MINERALS PROGRAM INSPECTION REPORT

MINE NAME: Cresson Project	MINE/PROSPECTING ID#: M-1980-244	MINERAL: Gold	COUNTY: Teller
INSPECTION TYPE: Monitoring	INSPECTOR(S): Elliott Russell	INSP. DATE: September 2, 2021	INSP. TIME: 10:00
OPERATOR: Cripple Creek & Victor Gold Mining Company	OPERATOR REPRESENTATIVE: Jeana Ratcliff	TYPE OF OPERATION: 112d-3 - Designated Mining Operation

Photo 1. Schist Island backfill, first 20-foot lift; looking east.

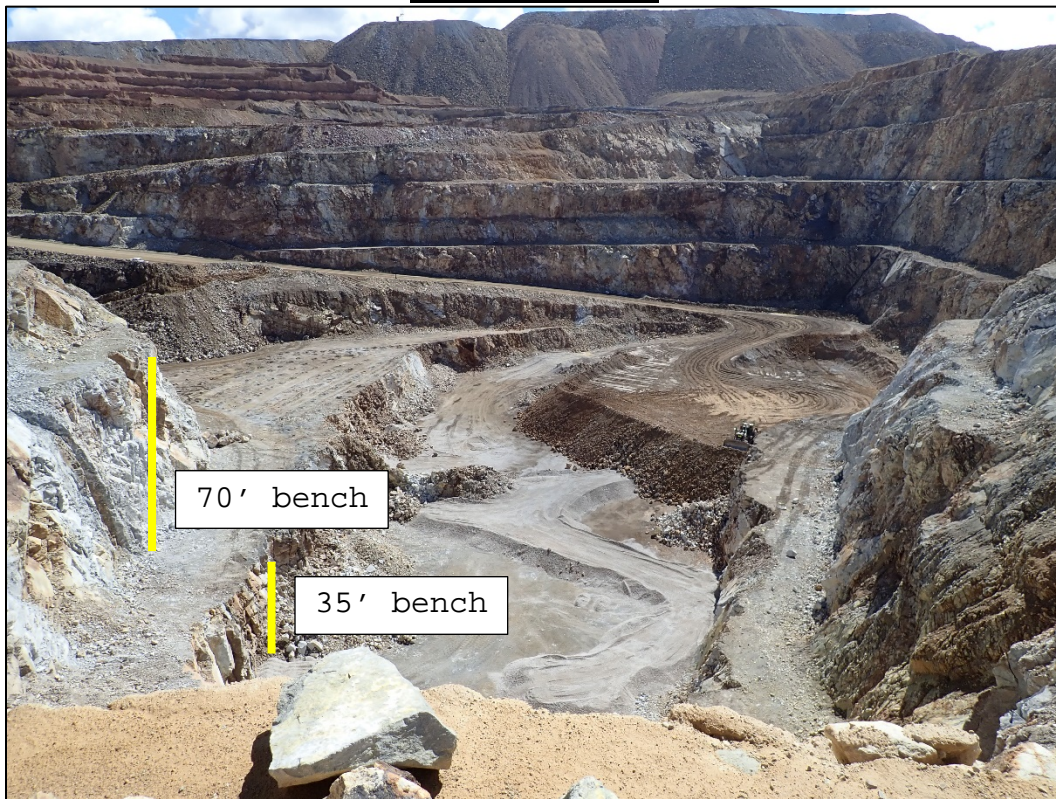
Prior to the inspection, the Operator notified the Division that backfilling operations in the Schist Island Pit would commence the week of August 30th. The first low compaction lift, at height of 20 feet, was being backfilled at the time of the inspection (see **Photo 1** and **Photo 2**). This lift was started in the southeast corner of the pit and was advancing to the north and west. The Operator stated the plan is to complete four lifts with heights of 20, 15, 20, and 20 feet. The second lift is planned for only 15 feet because the Operator needs complete remediation of historic workings on the first 35-foot highwall bench in the northern part of the pit. The Division observed several haul truck cycles during the inspection and all material dumped appeared to pass the approved specification of all material being smaller than 60 inches (see **Photo 3**). One truck contained a rock larger than 60 inches, but was flagged by a shift supervisor while the truck was descending into the Schist Island Pit (see **Photo 4**); this truck was rerouted to the ECOSA and the Operator stated the shift supervisor had a follow-up discussion with the equipment operator who loaded the oversized material into the haul truck. Based on the Division’s observations, CC&V was complying with the Amendment 13 Schist Island Backfill Specifications at the time of the inspection.

Photo 5. Gulley where foam was reported; looking south.

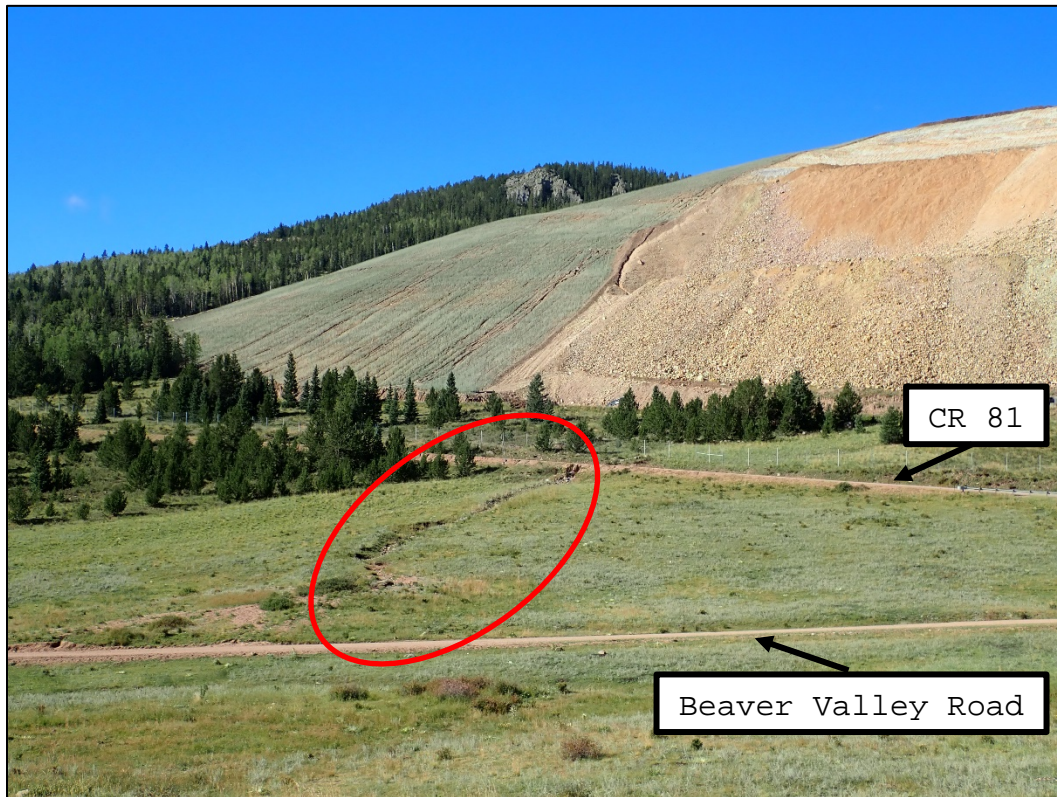
On August 17, 2021, the Division was copied on a CDPHE incident spill report regarding a caller who reported white foam on Beaver Creek on August 15th. The caller alleged the foam was from the Victor Mine and provided a location of 100 yards east of CR 81 and Beaver Valley Road. Following the incident report, the Division was involved in multiple discussions with CDPHE and Colorado Parks and Wildlife. It was believed the foam was directly associated with the August 15th storm event and that it was likely no longer visible. Additionally, it was discussed that the operation has no processing facilities nor chemical usage within the area of the report. CDPHE requested the Division, during the next monitoring inspection, inspect the area where the caller reported the source of the foam, a gulley at approximately 38°44'27.36"N 105° 7'15.81"W just down gradient of a culvert under CR 81 (see **Photo 5**). The Division inspected this gulley, the culvert, and the path of stormwater associated with CR 81 and the adjacent area above the culvert (see **Photo 6**). The eastern side of the CR 81 culvert contains significant erosion head-cutting and the culvert is suspended in the air with an approximate 12” drop (see **Photo 7**). The Division inspected the western bar ditch of CR 81 from above the culvert to the crest of the drainage divide, approximately 3,200 feet to the south. The Division observed no evidence of any recent sedimentation or erosional features entering into the bar ditch from the permit area which is located west of CR 81 (see **Photo 8**).

Photo 14. Aerial overview of the ECOSA, perimeter ditch identified by dash line; looking west.

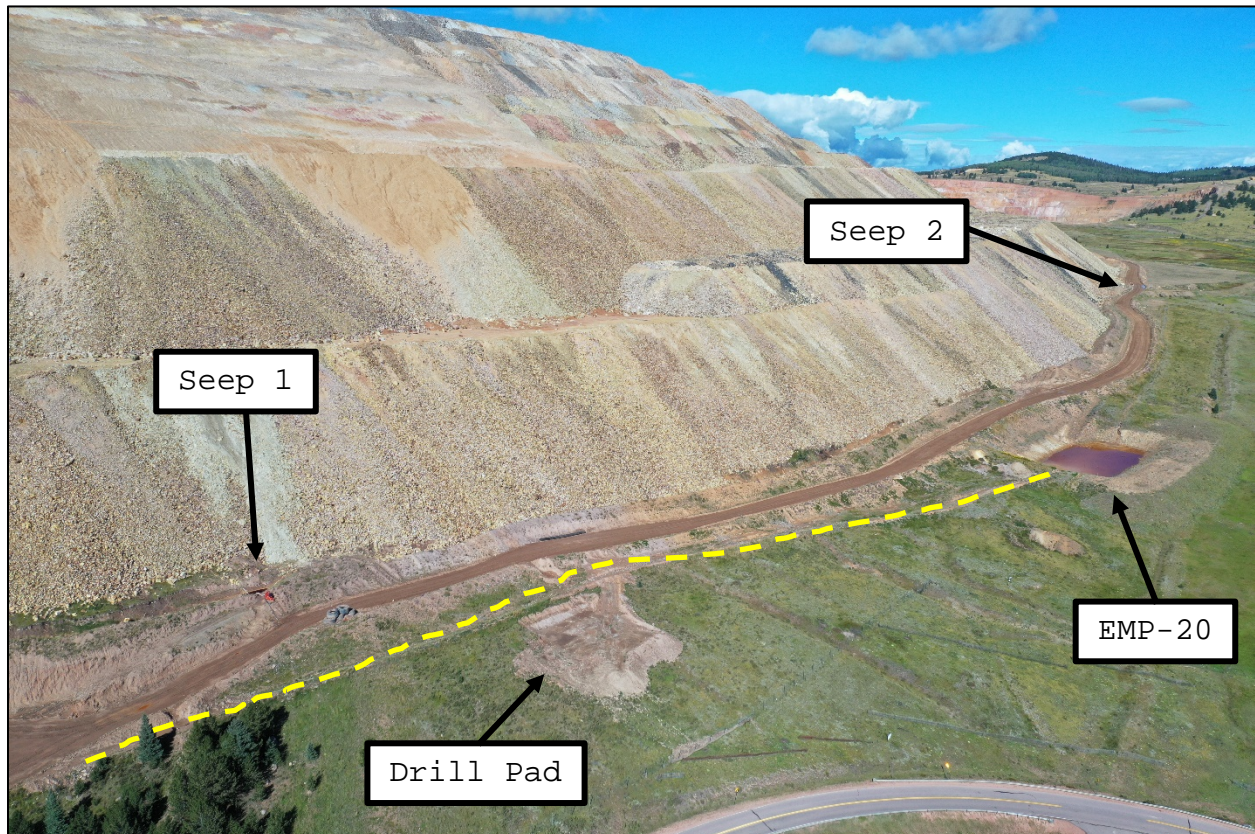
COMPLIANCE PROBLEM #3: A stormwater ditch failed and caused sediment to accumulate on undisturbed lands within the permit boundary. Additionally, an inactive drill pad, located west of the ECOSA near EMP-20, does not have adequate stormwater and sediment controls in place. This is a problem at this time for failure to protect the affected land from erosion pursuant to Rule 3.1.6 and C.R.S. 34-32-116(7)(i).

While inspecting the area between the original seep and EMP-20, the Division observed a large sediment deposit located against the wildlife fence, just downgradient of an inactive drill pad (see **Photo 13** and **Photo 14**). The Operator stated that this damage occurred during a storm event on July 16th where a section of the ECOSA's perimeter stormwater ditch failed and caused stormwater and sediment to flow across the drill pad and deposited against the fence. This failure appears to have been at the location of where the access road to the drill pad crossed the ditch. The inactive drill pad had berms along the northern and eastern sides, but no berm was along the southern side where the stormwater and sediment had traveled off the pad (see **Photo 15** and **Photo 16**). Furthermore, the edge of the drill pad disturbance did not have any sediment control features (silt fencing, straw wattles, catch ditches/berms, etc.). Following the storm event, the Operator repaired the ditch and increased the height of the outside ditch bank in several areas (see **Photo 17**), however the sediment that had been deposited on the undisturbed lands against the wildlife fence had not been cleaned up. Additionally, no further stormwater controls were installed around the inactive drill pad to control sediment from precipitation falling within the footprint of the drill pad. This has been cited as Compliance Problem #3 requiring the Operator to remove the deposited sediment and reclaim the disturbance between the drill pad and the wildlife fence. The Operator will also need to install stormwater controls for the drill pad. The Operator also discussed the possibility of reclaiming the inactive drill pad; this is an option, however, stormwater controls will still need to be constructed/installed along the edge of the reclaimed footprint until adequate vegetation is established. Lastly, the Operator will need to demonstrate the ECOSA perimeter ditch is appropriately sized and constructed to safely convey the modeled 100yr/24hr storm event to EMP-20. The Operator mentioned they had recently constructed the final reclamation 500yr channel along the reclaimed portions of the ECOSA above the area where clay was currently being mined and that the plan is to continue this channel once the clay area is backfilled and graded. As this area is just above the ditch which failed in the recent storm event, the Operator may want to submit the designs to construct the 500yr channel all the way to EMP-20 as a part of the corrective action, however, the minimum requirement at this time is for the 100yr/24hr event.

CORRECTIVE ACTIONS: The Operator shall provide photo documentation to the Division verifying the deposited sediment has been appropriately cleaned up and sediment control measures have been installed/constructed around the drill pad by the corrective action date. Additionally, the Operator shall demonstrate the repaired ECOSA perimeter ditch is appropriately sized and constructed to safely convey the modeled 100yr/24hr storm event to EMP-20 by the corrective action date
